Re: The Original Pancake House
5161 Journal Center
Traffic Circulation Layout
Engineer's Stamp Dated 9-20-24 (D18D061)

DRAINAGE AND TRANSPORTATION INFORMATION SHEET

The Original Pancake House
5161 Journal Center Blvd NE
Albuquerque, New Mexico

FIRE 1
9/20/24

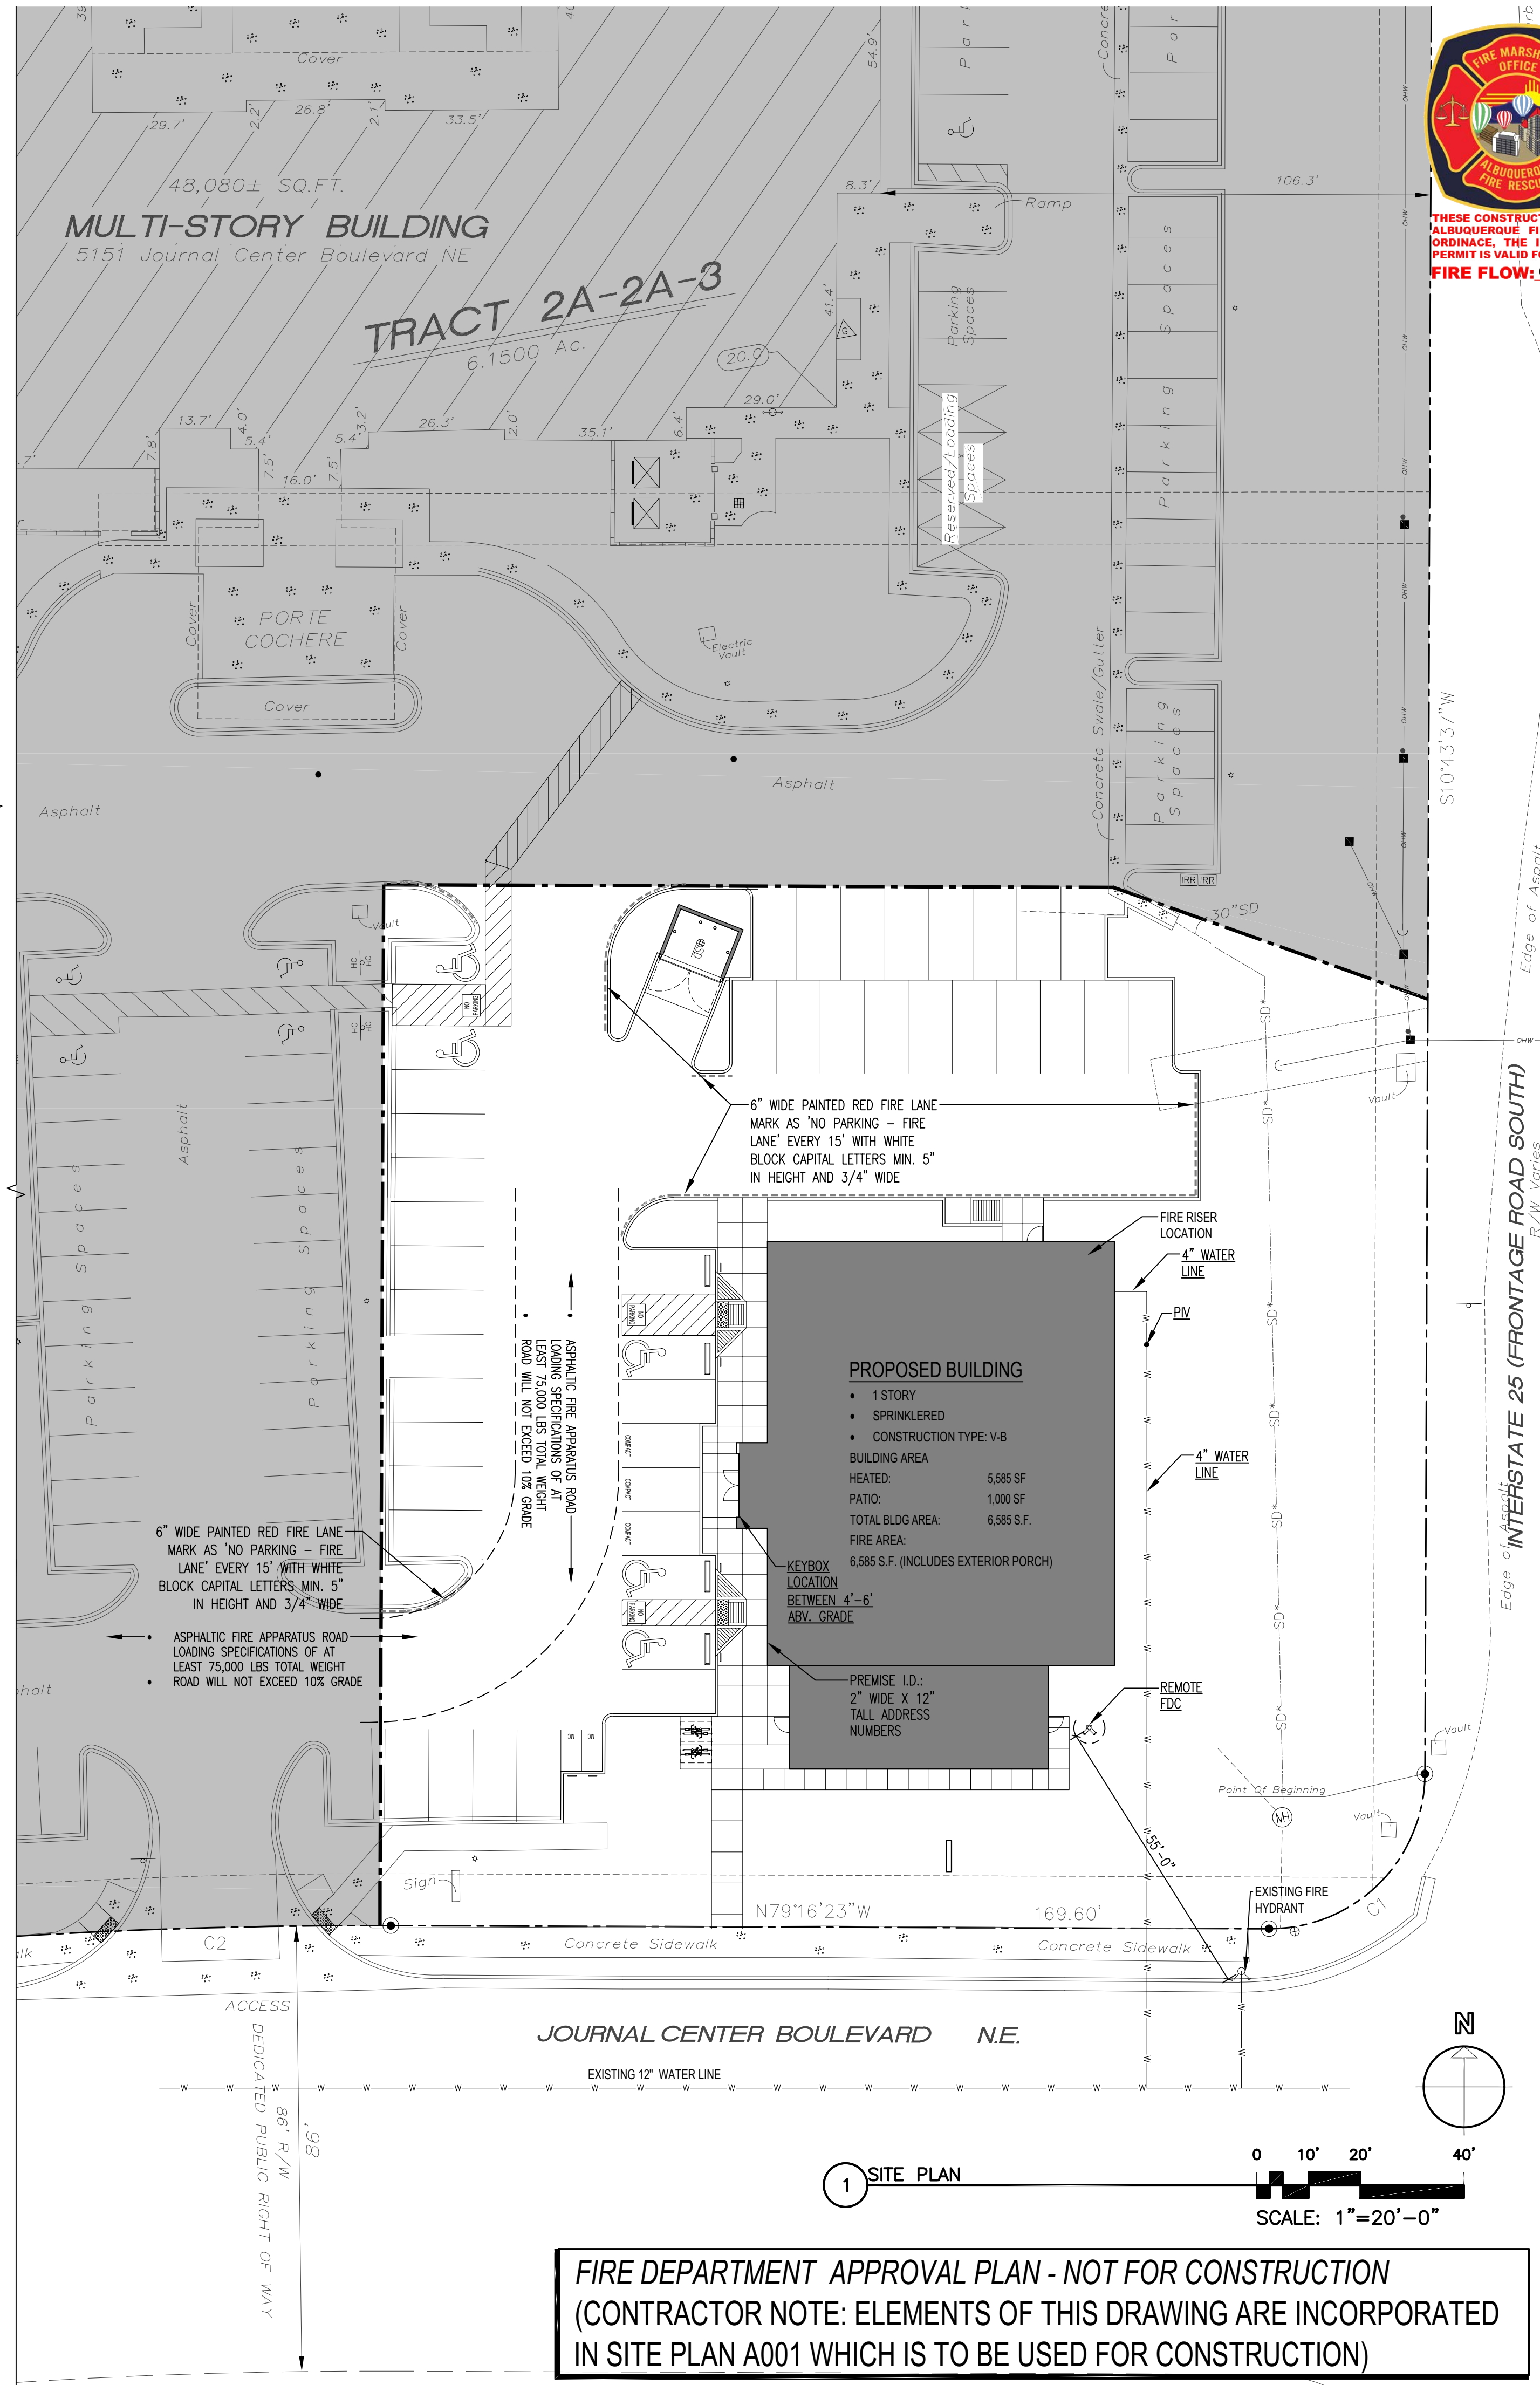
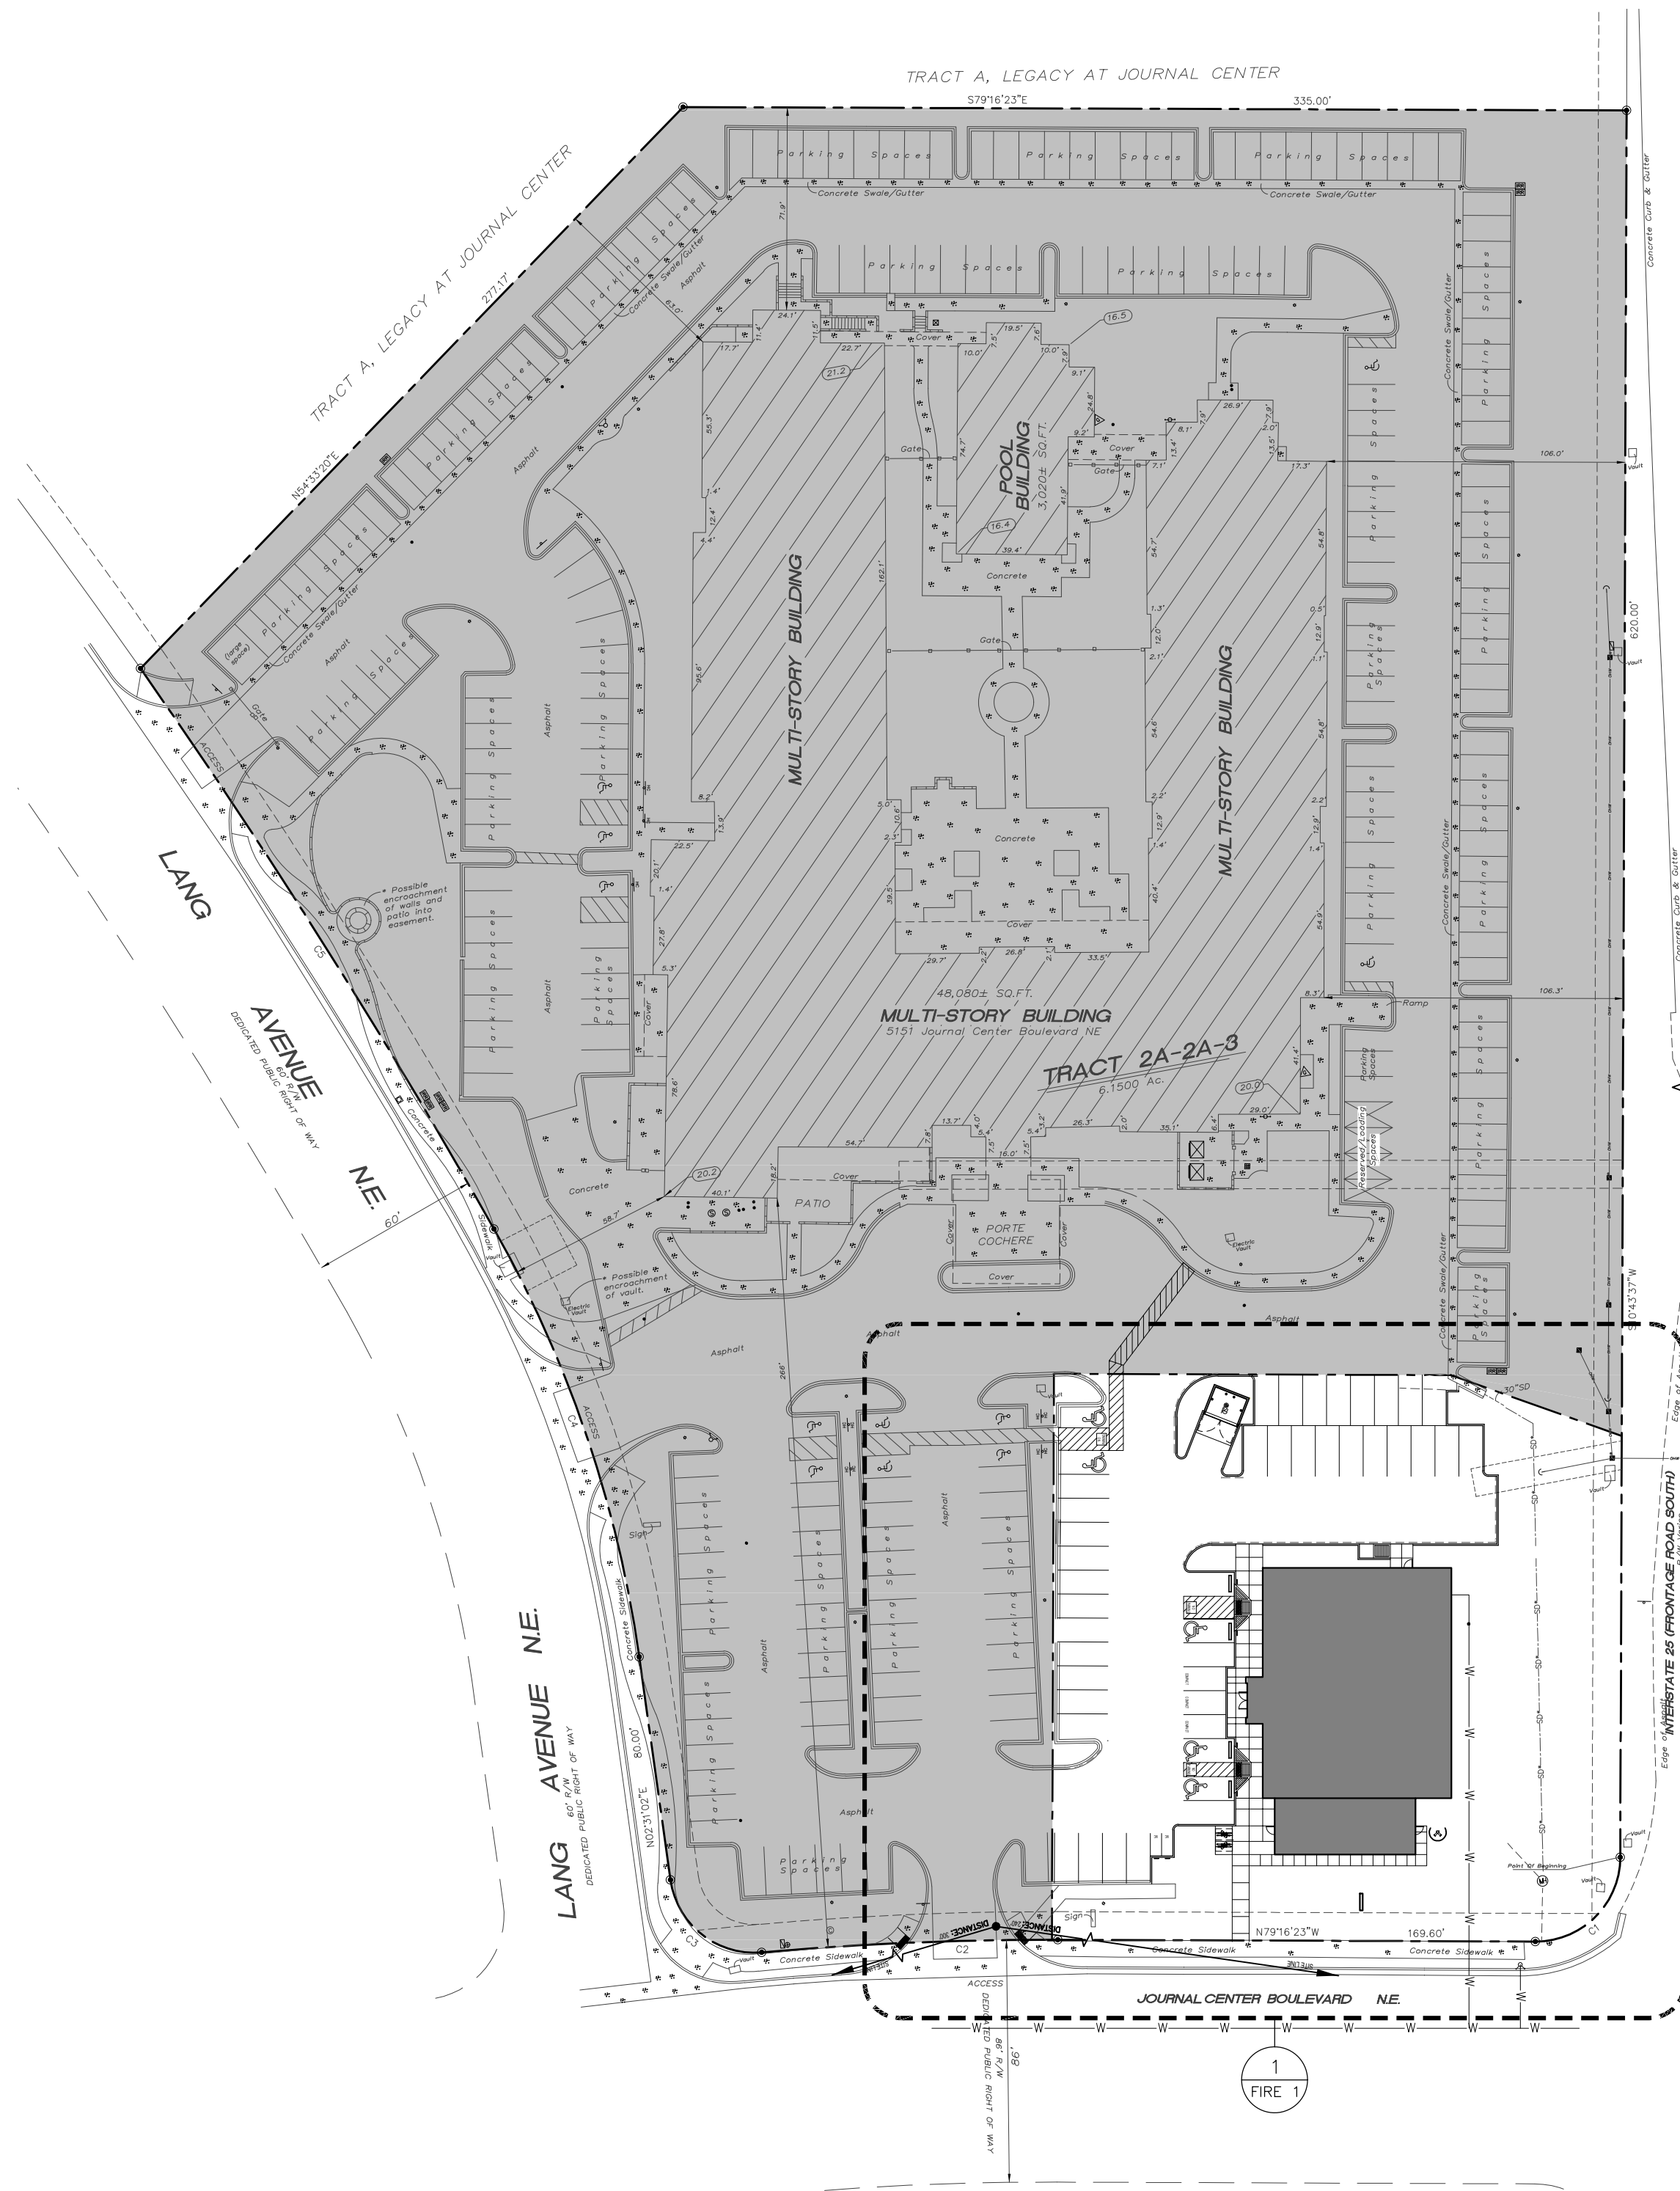
THESE CONSTRUCTION DOCUMENTS WERE REVIEWED AND APPROVED BY THE ALBUQUERQUE FIRE MARSHAL'S OFFICE IN ACCORDANCE WITH THE CITY ORDINANCE, THE INTERNATIONAL FIRE CODE, AND NFPA STANDARDS. THIS PERMIT IS VALID FOR 180 DAYS. FINAL INSPECTION IS REQUIRED.
FIRE FLOW: 6,585sqft, VB, -Sprinklered, 1500gpm, 1 Hydrant
